UNITED STATES PATENT AND TRADEMARK OFFICE

APPLICATION NO.	FILING DATE	FIRST NAMED INVENTOR	ATTORNEY DOCKET NO.	CONFIRMATION NO.
10/064,775	08/15/2002	David Michael Hoffman	125708	2570

Office Action Summary

DETAILED ACTION

Figures 1 and 2 (sectioned) – U.S. Patent 6,072,851 to Sivers

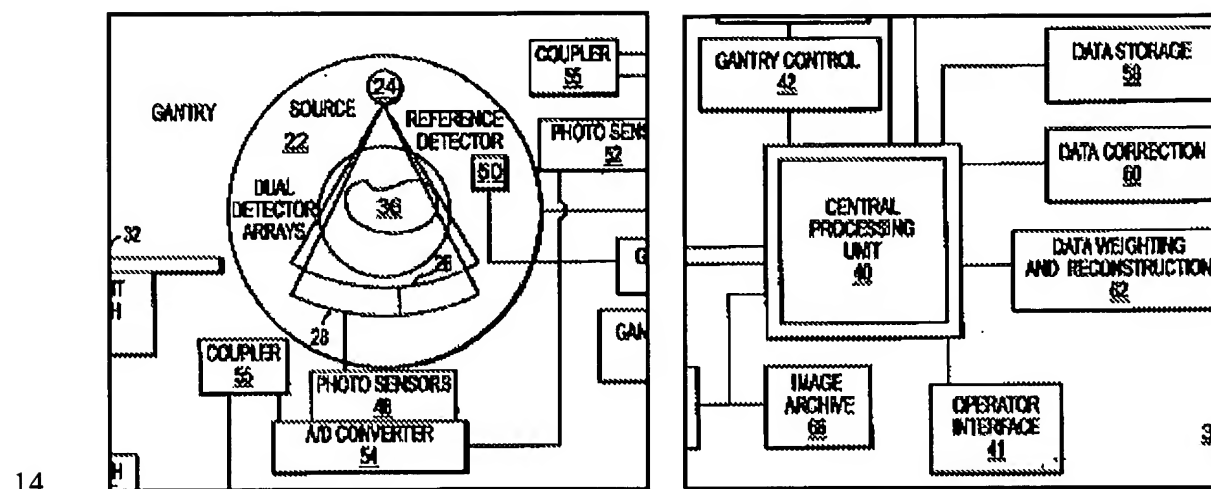
15. As per claims 1 and 30, Sivers discloses a computed tomography (CT) imaging system (20) comprising a gantry (22) wherein the gantry defines a patient cavity (34) and includes an X-ray source (24) and a radiation detection apparatus, wherein the radiation detection apparatus includes a first radiation detector (26) and a second radiation detector (28) and wherein the X-ray source (24) and radiation detection apparatus (26, 28) are rotatably associated with the gantry (22) so as to be separated by the patient cavity (34); a patient support structure (32) and a processing device (40).

16. As per claim 3, Sivers discloses a computed tomography (CT) imaging system wherein the first radiation detector (26) is disposed so as to be adjacent to the second radiation detector (28) (see Fig. 1, above).

17. As per claim 4, Sivers discloses a computed tomography (CT) imaging system wherein the first radiation detector (26) is disposed so as to be non-adjacent to the second radiation detector (28) (Examiner notes that detectors 26 and 28 are off-set from each other - see Fig. 2, above).

18. As per claim 6, Siverson discloses a computed tomography (CT) imaging system wherein the X-ray source (24) includes a first X-ray emitter opposingly disposed relative the first and second radiation detectors (see Fig. 1 above).

Figure 1 – U.S. Patent 6,421,412 to Hsieh et al.

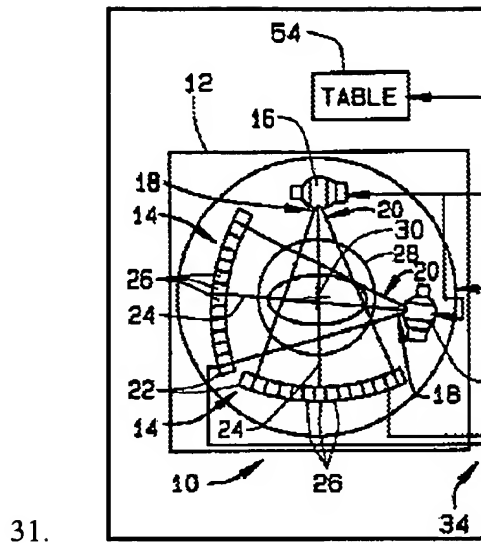
32. Hsieh et al. disclose an imaging system wherein the X-ray source includes a first X-ray emitter opposingly disposed relative to the first radiation detector and wherein the X-ray source includes a second X-ray emitter opposingly disposed relative to a second radiation detector. Hsieh et al. teach the use of two source-detector pairs in an imaging system as a means for generating images of an internal organ, such as a heart without significant motion artifacts. Hsieh et al. further suggest that the use of the two-source-detector pairs reduces patient exposure by collecting projection data at a sufficiently high rate (see column 2, lines 35-37, 51-55; column 3, lines 3-6).

33. It would have been obvious to modify the imaging system of Sivers such that it incorporated a first X-ray emitter opposingly disposed relative to the first radiation detector and a second X-ray emitter opposingly disposed relative to a second radiation detector. One would have been motivated to make such a modification so that the imaging system is optimized to a) acquire projection data of the internal organs of a patient without significant motion artifacts and b) to reduce radiation exposure to a patient due to the systems' multiple data
